19117-01-001

Proposed Residential Development at Spencer North, Dublin Docklands

QUALITY AUDIT (incorporating a walking and road safety audit)

CS Consulting

Ground Floor Plan

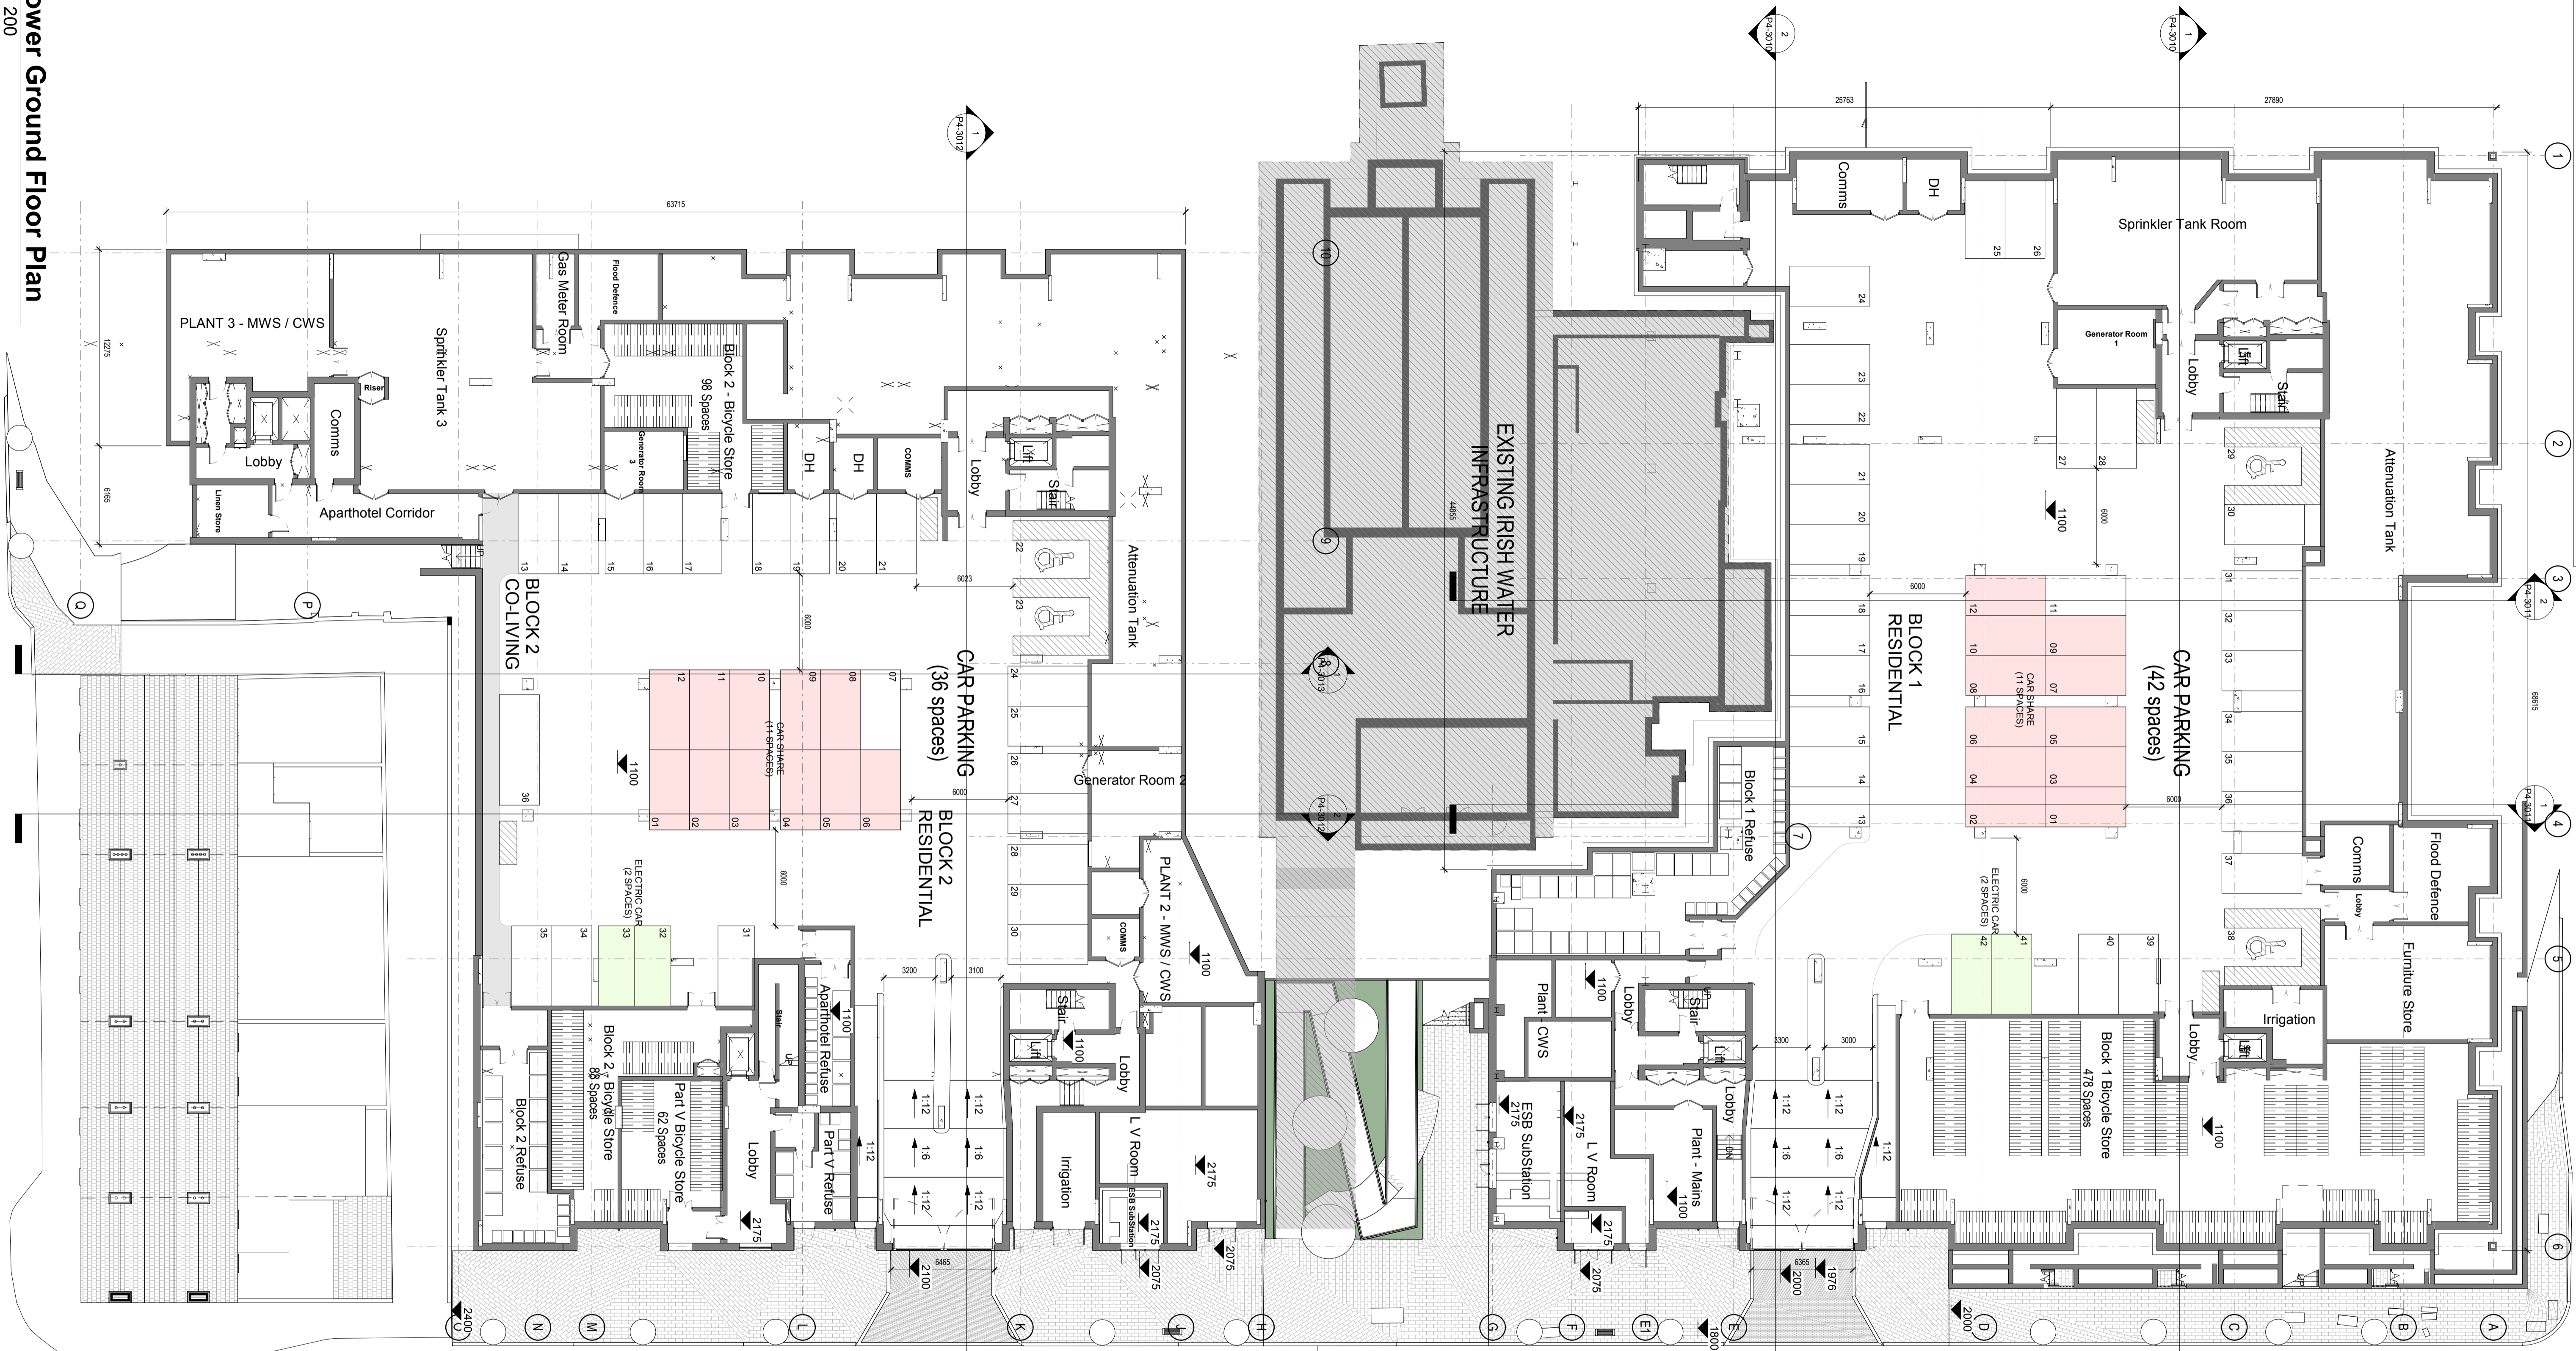
Block 1 ground floor has two floor levels: 4.7m and 5.225m. There are 3 lifts, two of which serve the 4.7m level only. If mobility impaired users require access to the 5.225m level areas they must use the lift at quadrant E5. Those unfamiliar with the building may be unaware of that requirement and might use the incorrect lift.

There are two columns within the area traversed by cars in the car park of Block 1. They are located within the road to the front of parking spaces numbered 22 and 23. They could be struck by vehicles. In addition, drivers may be unaware which side of the column to travel on for the best approach to the western parking spaces.

The distance between car park space numbered 30 and the wall of the stairwell to its east appears to be 600mm or so. This area is the passage

leading to the lift serving the east (residential) area of Block 2 and appears to be the only lift serving this area. Users of the accessible parking spaces will therefore rely on it. It will not be accessible by wheelchair if a vehicle parked in space number 30 obstructs the width required for universal access. In addition, the corridor leading to the lift appears narrow.

The floor level of the café and reception of Block 2 shared accommodation is 3.5m; the level of the plant rooms below are 1.1m. Floor to ceiling heights may be insufficient in the plant rooms.

An accessible toilet is shown to be provided in Block 1 but not in Block 2. Such facilities would be required adjacent to the café, reception and gym in the shared accommodation.

The floor level of the café is 3.5m. Assuming a level entry threshold at the café entrance, the path level will be similar. The path level is shown to be 2.45m some 18m to the east. The gradient of the public footpaths could be excessive.

The external ramp located between the door to the lobby and the door to the reception at Block 1 is too steep for universal use.

It is assumed that the green space shown on the Ground Floor Plan adjacent to the public footpath at Sheriff Street (between grid lines 3 and 4) is not publicly accessible from the street and does not need to be provided with public amenities such as seating, lighting, street furniture etc.

There is a discrepancy between the proposed levels of the footpath on Mayor Street shown on different drawings: the site plan shows 2.7m (mid-way along Mayor Street) and the Ground Floor plans shows 2.45m.

The surface level of the entrance to the underground car park of Block 1 is shown as 1.710m on the ground floor plan and as 2m on the lower floor plan.

Provide directional signage within the underground car park and at the entry to the courtyard area of Block 1 directing users to the appropriate lift serving the reception area.

Mark the columns with reflective markings and provide a guide line on the floor of the car park extending from space numbered 18 to the first column to indicate the route to the downstream parking spaces.

Move parking spaces numbered 28, 29, and 30 westwards to provide the necessary width and ensure that adequate corridor width is available to provide universal access from the car park to Block 2 residential.

Provide adequate floor to ceiling heights.

Ensure that the WC shown to be provided in Block 1 (at the café) is suitable for universal use.

Revise the levels to ensure the gradient of the footpath is adequate for universal use.

Ensure that the alternative route via the internal lift is always open and available to users.

Lower Ground Floor Plan

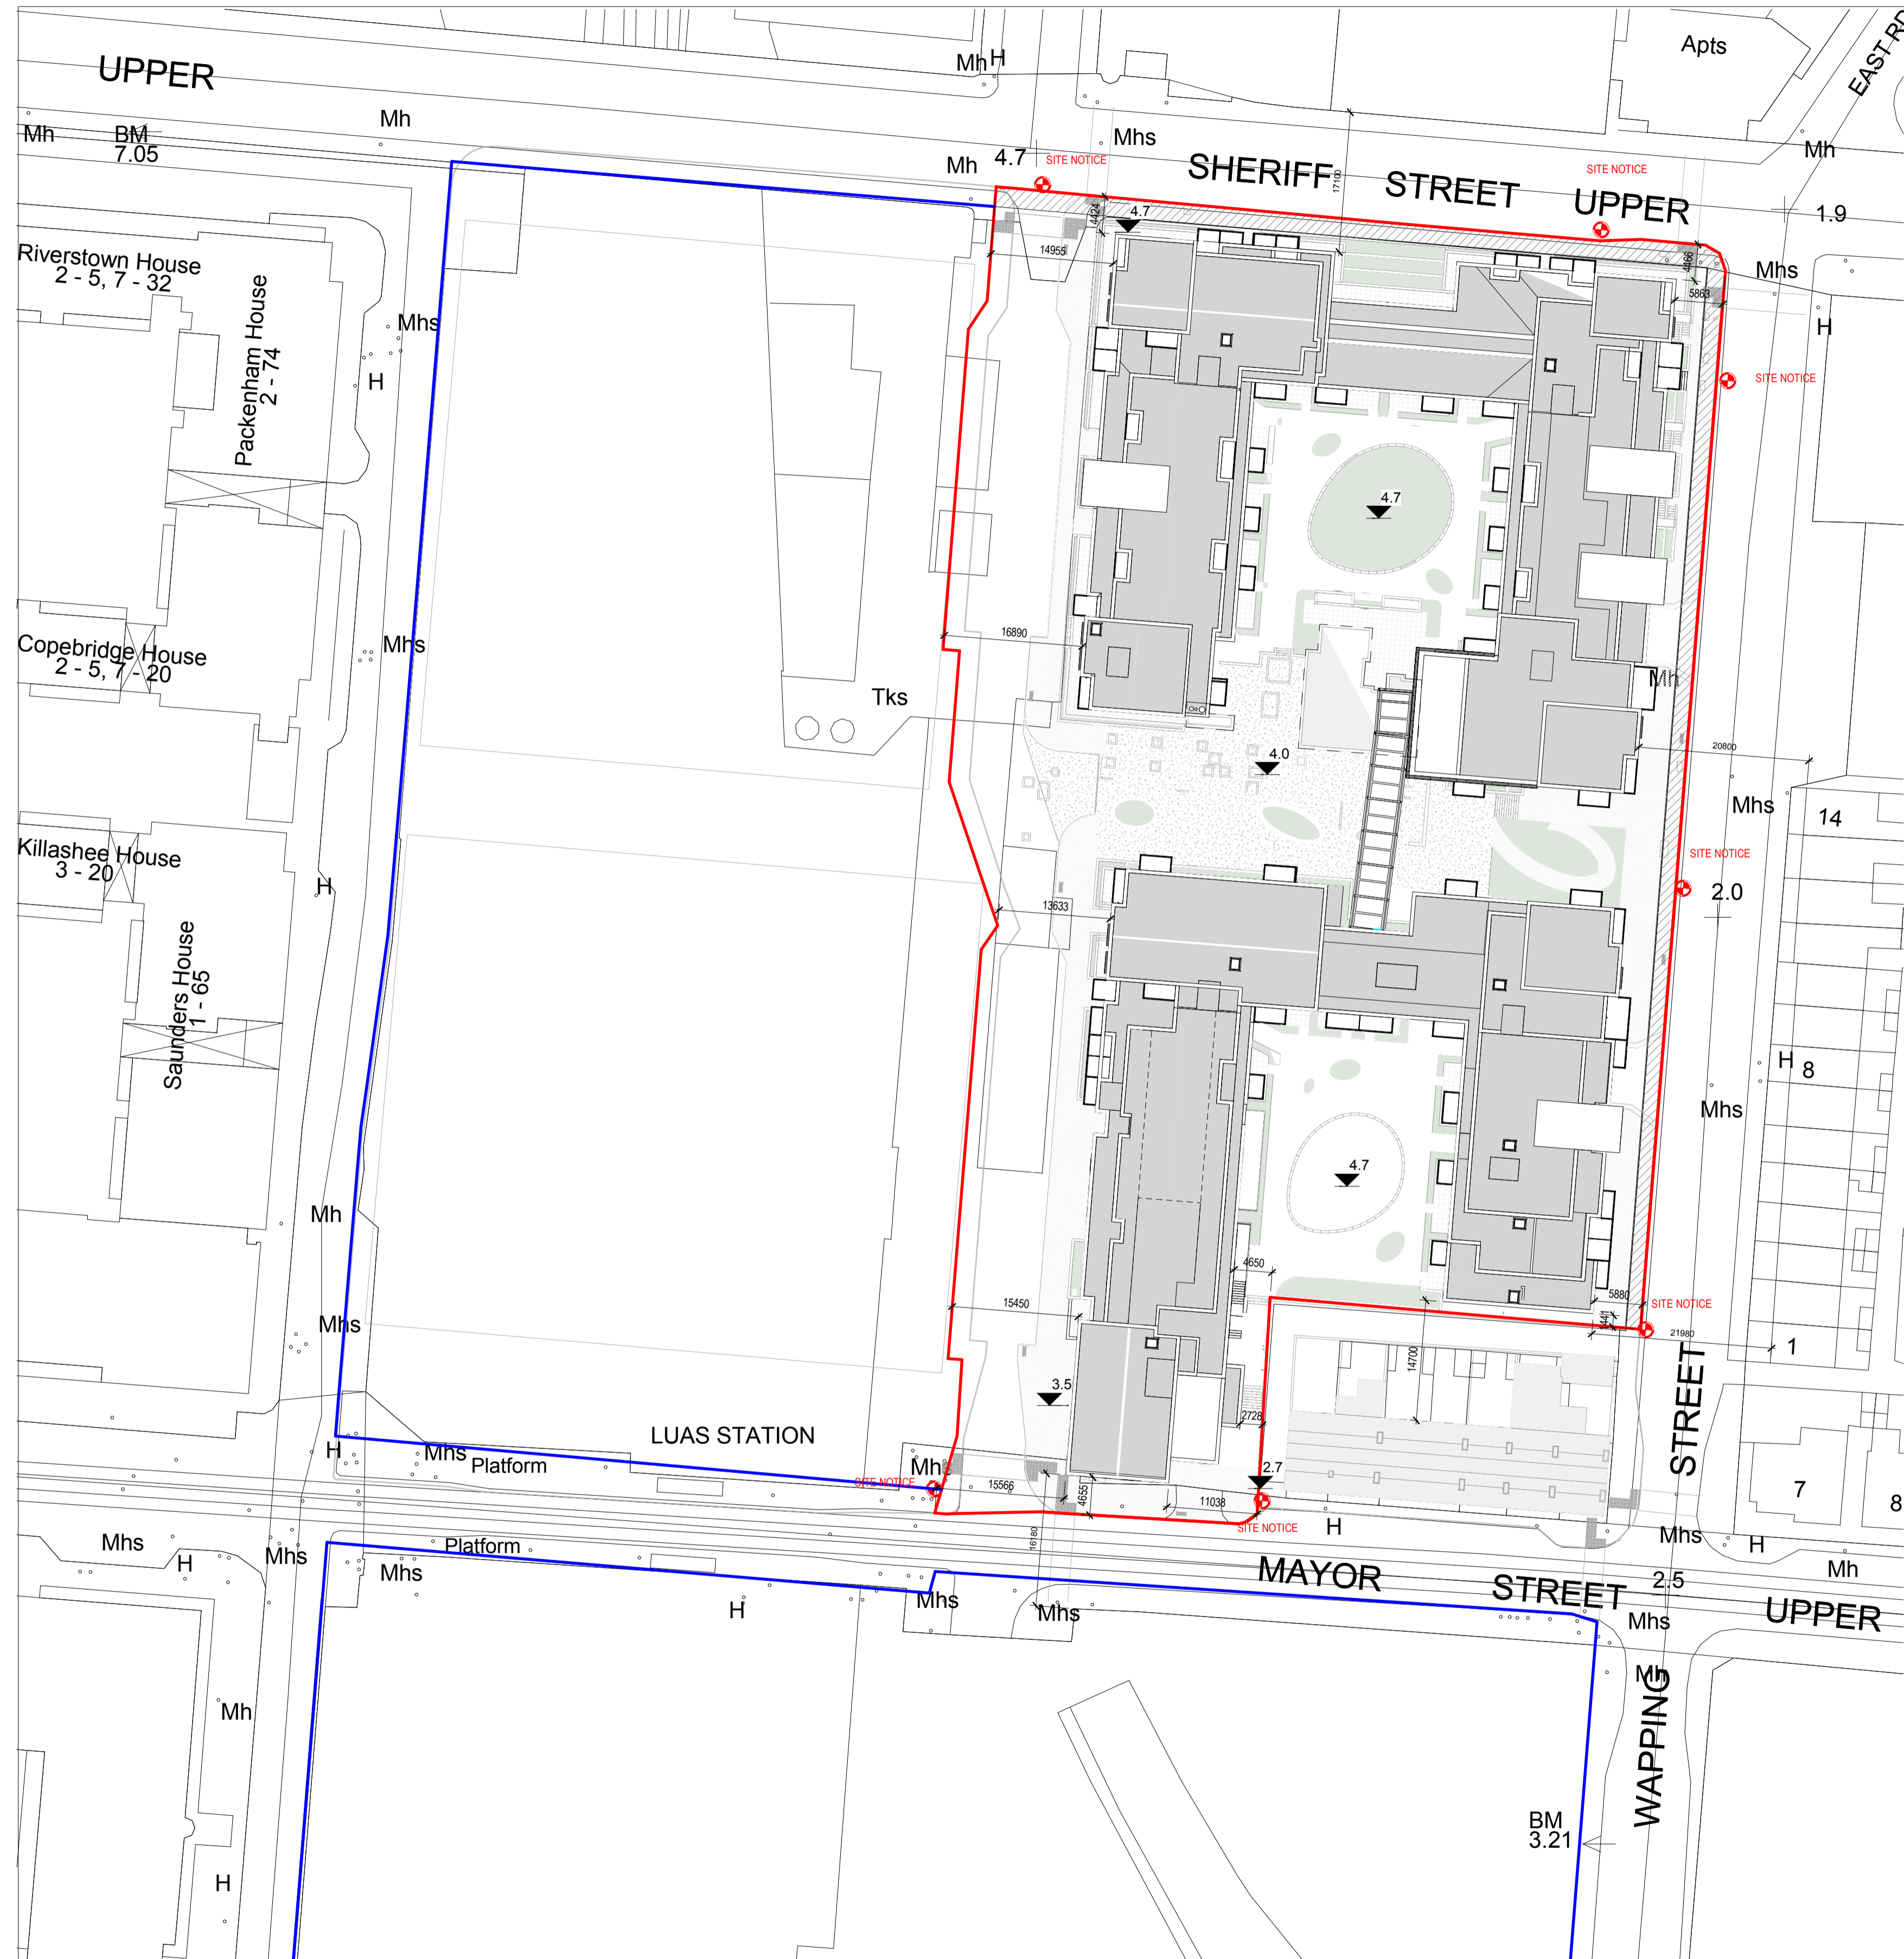
There will be routine pedestrian trips through the underground car parks, some of which will not be associated with car parking: the Block 1 refuse stores is remote from the northern lift and residents will traverse the car park when depositing waste; the Block 2 bicycle stores are remote from the lift shafts (the lift shaft beside the eastern bicycle store does not appear to serve the store). Users will therefore wheel their bikes and carry their refuse through the car parks. There are no specific provisions for separation of vulnerable users from vehicular traffic.

There will be foot traffic across the foot of the ramps to the underground car parks. The refuse stores are located to the south of the ramps and the lifts (to non-Part V residents) are located to the north. Drivers descending the ramp may not expect pedestrians to cross ahead of them.

Doors to plant rooms in the underground car parks open outwards and car parking spaces are provided in front of some doors. Access may be obstructed by parked vehicles. The west side of Block 2 car park has the most frequent incidence.

Provide a delineated route for pedestrians (including those wheeling bikes) around the outside of the circulating road of each car park.

Provide a marked crossing point for pedestrians with advance signage to warn descending drivers.

If unobstructed access is required, amend the parking layout to ensure it is available.
